Report: Issues

Function: Test, Adjust, & Balance

CW 2999 - UTSW (DALLAS, TX)

Issue Name : VRH-3-22

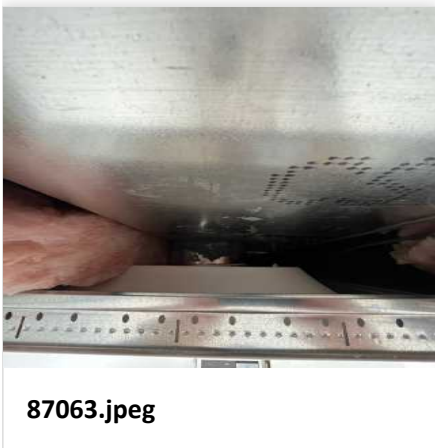
Description : Diffuser 4 does not have a damper and is thus extremely high on CFM. The diffusers is extremely close to the main duct as well.

Issue Name : VRH-3-22

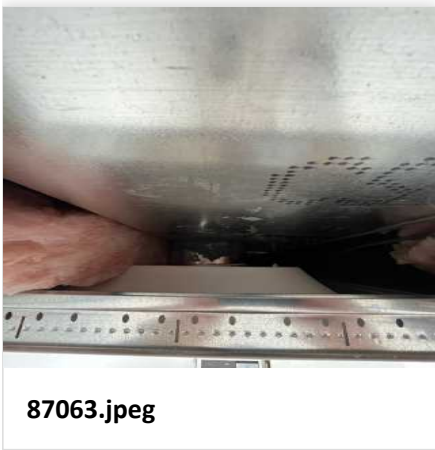
Description : Diffuser 4 does not have a damper and is thus extremely high on CFM. The diffusers is extremely close to the main duct as well.
